Technical design note

Project name	Ancoats Garden		
Design note title	Discharge of Planning Conditions 5 & 9		
Document reference	C-24134-HYD-XX-XX-TN-C-0001		
Author	Josh Booth		
Revision	Po4		
Date	3 August 2023	Approved	✓

1. Planning Conditions 5 and 9

AGM-AJP-XX-00-DR-C-0001-P04 – Proposed Drainage Strategy

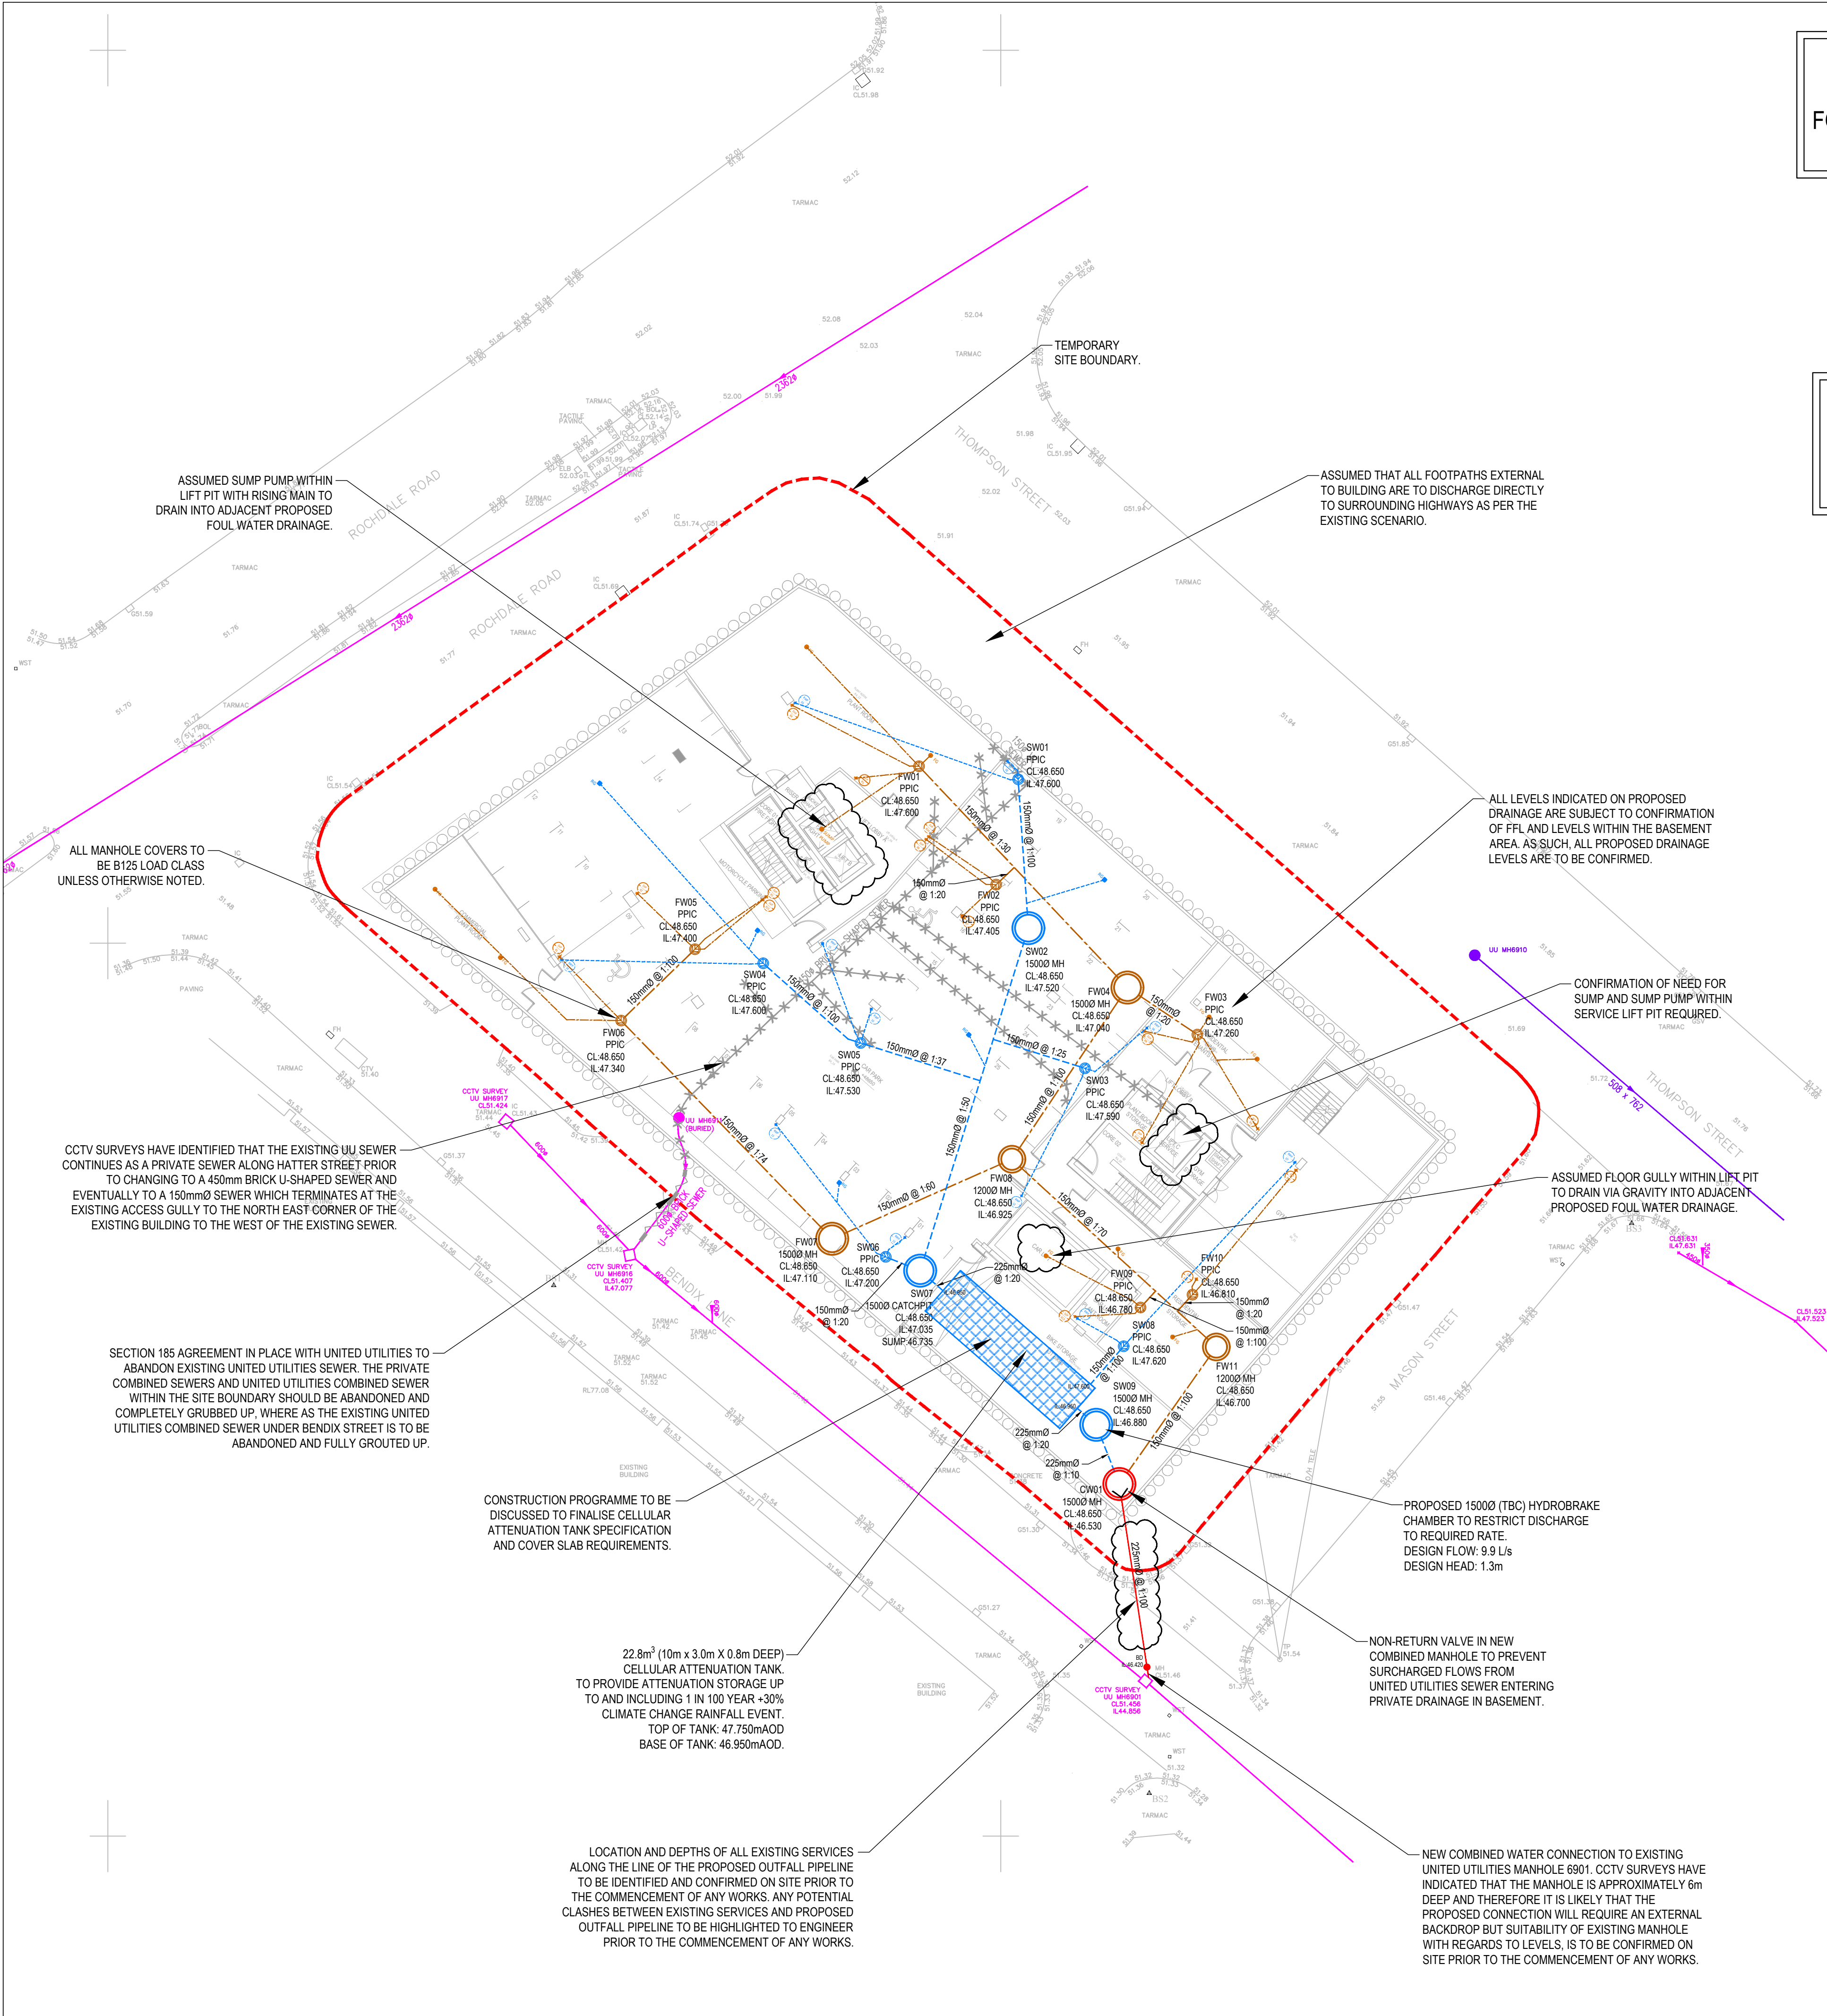
The proposed drainage has been constructed in accordance with the previously approved Alan Johnston Partnership drainage layout AGM-AJP-XX-00-DR-C-0001, which can be found within Appendix A.

AGM-AJP-XX-00-DR-C-0001-C01 – Proposed Drainage Strategy

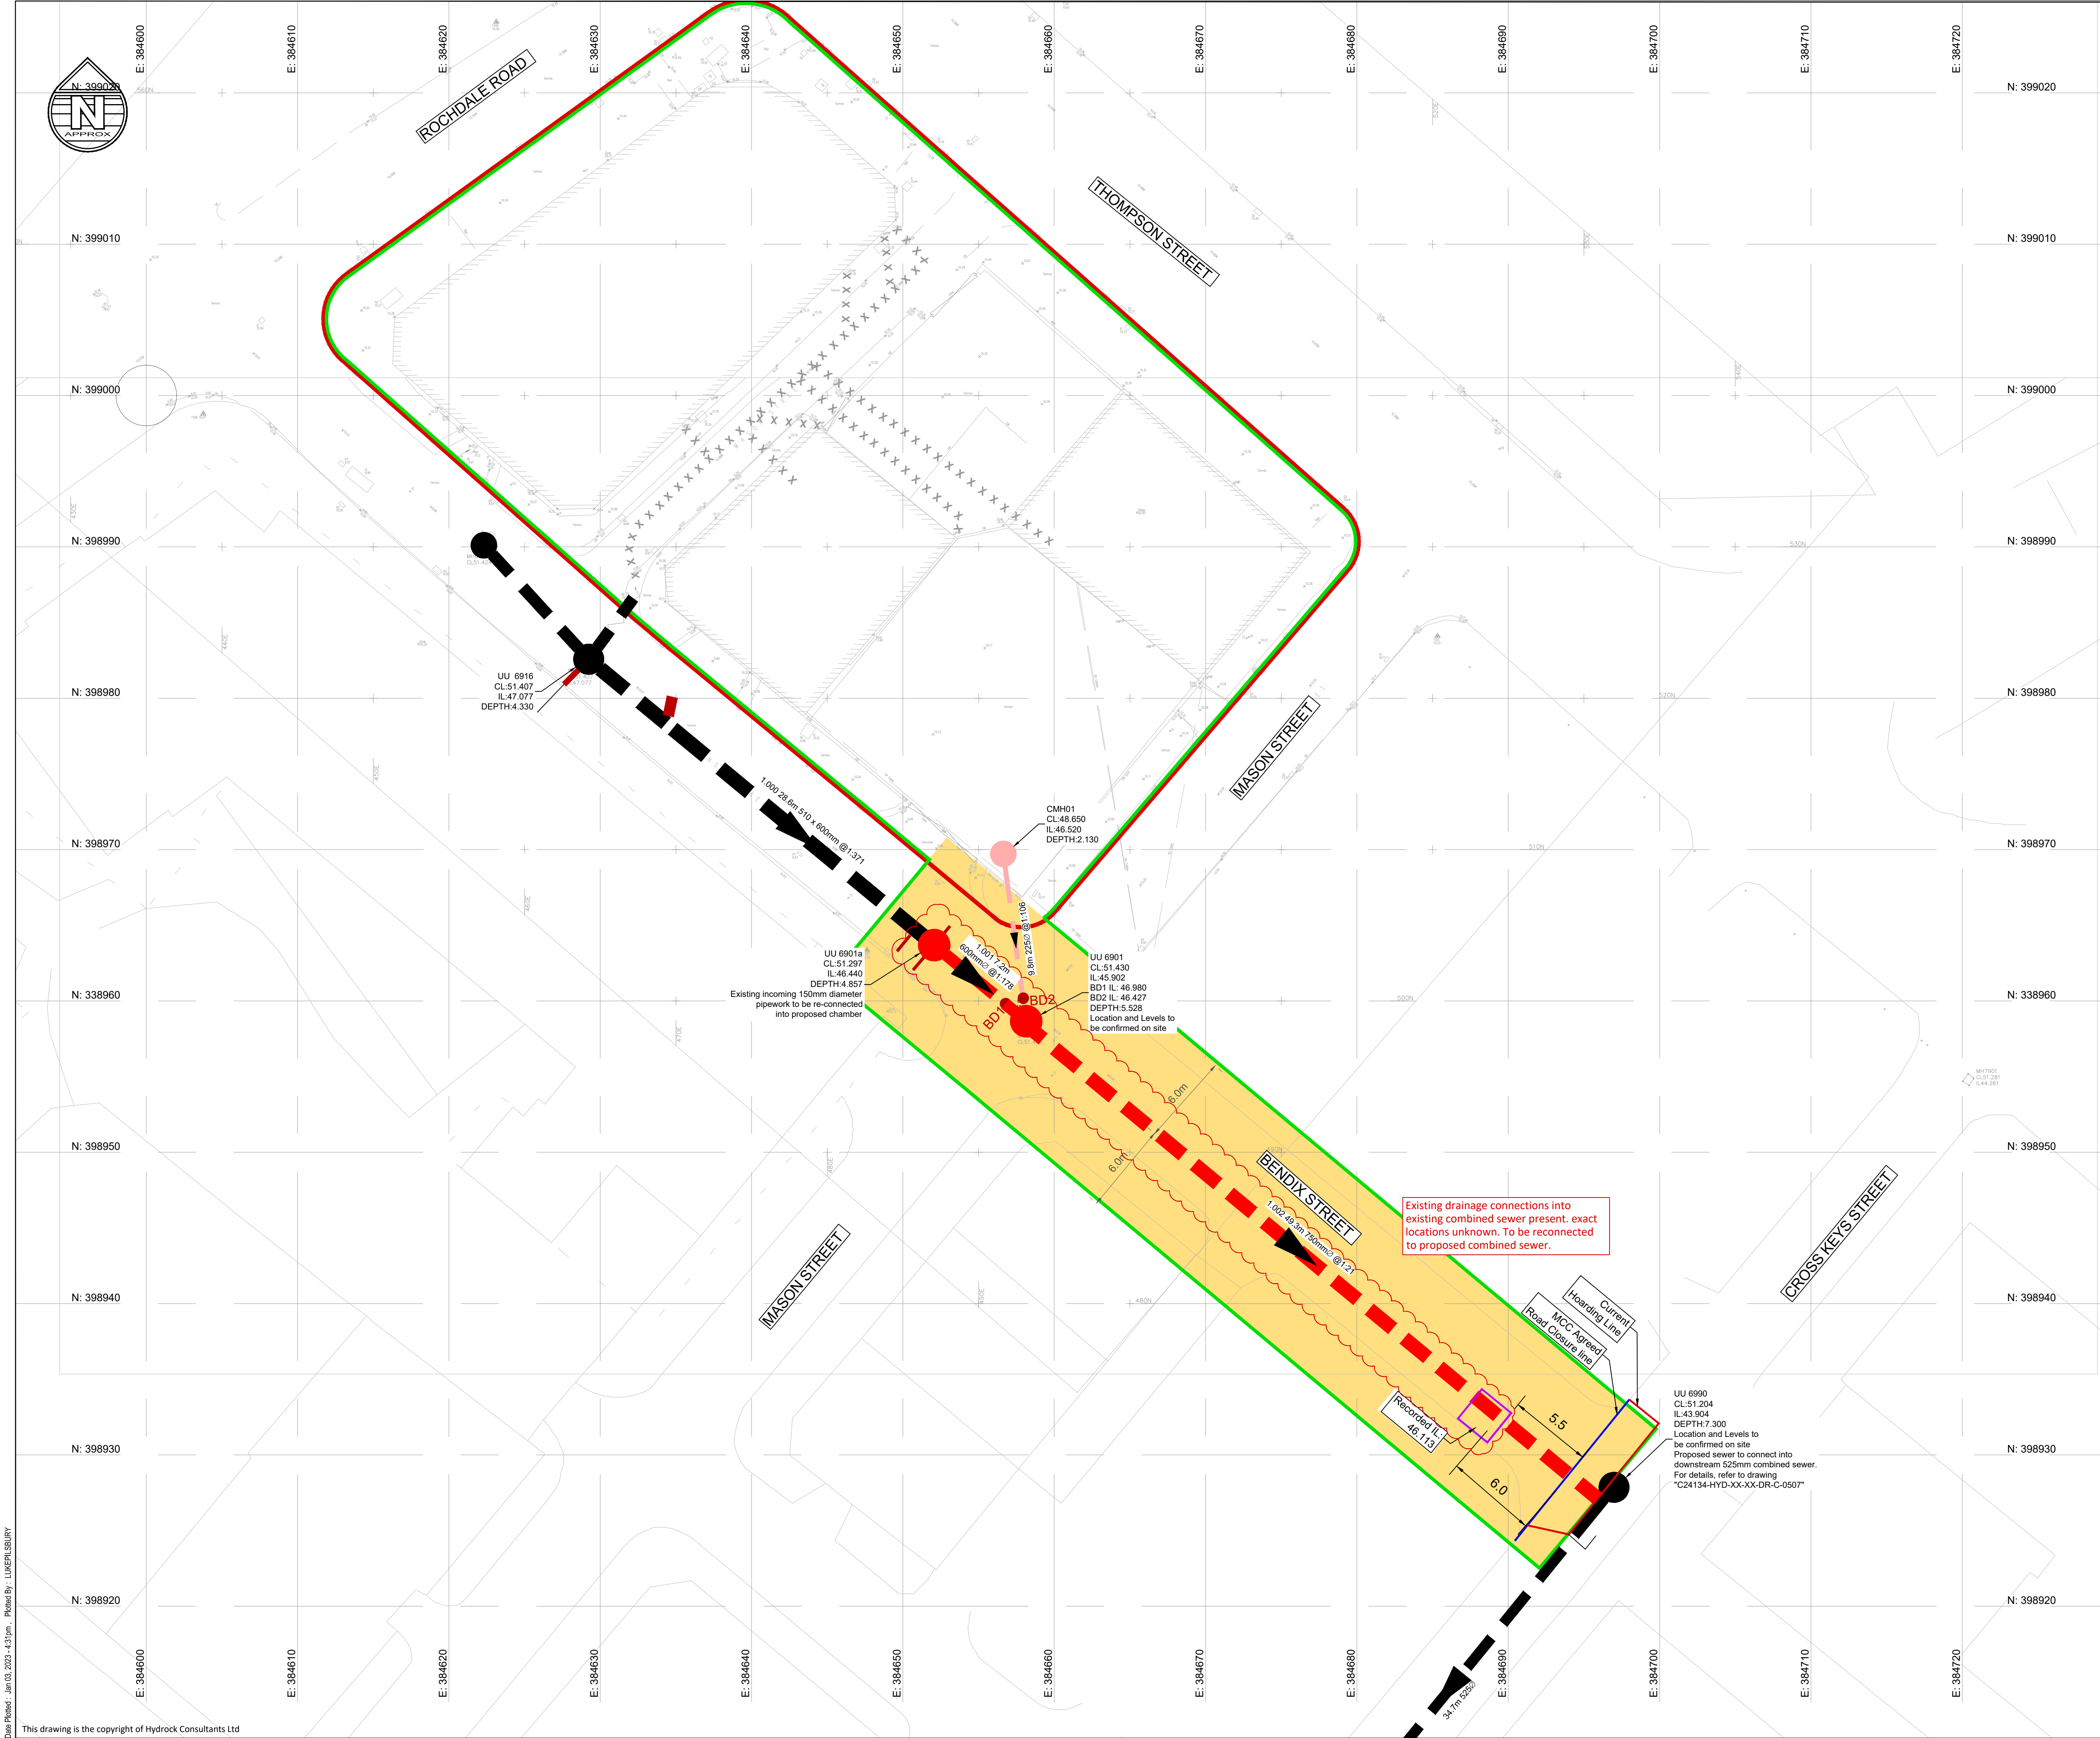
Between the Planning and Construction Phases of the proposed drainage, modifications were made to the arrangement of pipework, along with the reduction of attenuation volumes from 37.6m³ to 22.8m³. Hydrock updated the surface water drainage calculations within MicroDrainage to confirm that the performance of the drainage is the same as the approved design. The MicroDrainage calculations, which can be found with Appendix D, indicate that a flow rate of 9.9l/s is still achieved with the amendments to the pipe routes and attenuation.

The updated construction drawing AGM-AJP-XX-00-DR-C-0001 C01 is included in Appendix A which shows the above changes.
